## Access Compliance Report Public Rights-of-Way (Curb Ramps)

Intersection ID: 31188Main Street:BARBEE\_DRCross Street:CARVER\_POND\_RDLocation:NWADA ID: 79F9CA505F44Ramp Type:PerpDiagInitial Pass/Fail:FailOverall Compliance:NoSeverity Score:8.75

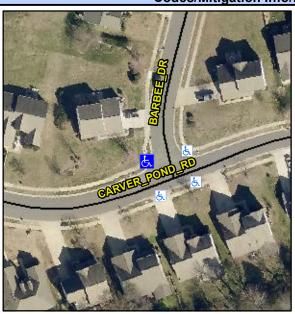
Not Found, R304.5.1

Field Measurements/Component Compilance					
Compliance Description		Data	Compliance Description		Data
N/A	Ramp Length (in)	48.0	Yes	Ramp Slope (%)	5.5
No	Ramp Width (in)	38.0	Yes	Ramp XSlope (%)	0.8
N/A	Flare Type LT	N/A	N/A	Flare Type RT	N/A
N/A	Flare Slope LT (%)	N/A	N/A	Flare Slope RT (%)	N/A
N/A	Flare Traversable LT?	N/A	N/A	Flare Traversable RT?	N/A
N/A	Landing Length (in)	N/A	N/A	DWS Provided?	N/A
N/A	Landing Width (in)	N/A	N/A	DWS Contrast?	N/A
N/A	Landing Slope (%)	N/A	N/A	DWS Length (in)	N/A
N/A	Landing X Slope (%)	N/A	N/A	DWS Full Width?	N/A
N/A	Landing Curb? (Y/N)	N/A	N/A	DWS Offset (in)	N/A
N/A	Shared Landing?	N/A			
N/A	Gutter Ponding?	Yes	N/A	Gutter Slope (%)	N/A
N/A	Gutter Lip Ht (in)	N/A	N/A	Gutter X Slope (%)	N/A
N/A	Painted X Walk1?	No	N/A	Painted X Walk2?	No
	X Walk 1 Direction	To S		X Walk 2 Direction	To E
N/A	X Walk 1 Width (in)	N/A	N/A	X Walk 2 Width (in)	N/A
	X Walk 1 Slope (%)	2.9		X Walk 2 Slope (%)	0.4

Remove & Replace Curb Ramp With Two New Directional Ramps or Equivalent.
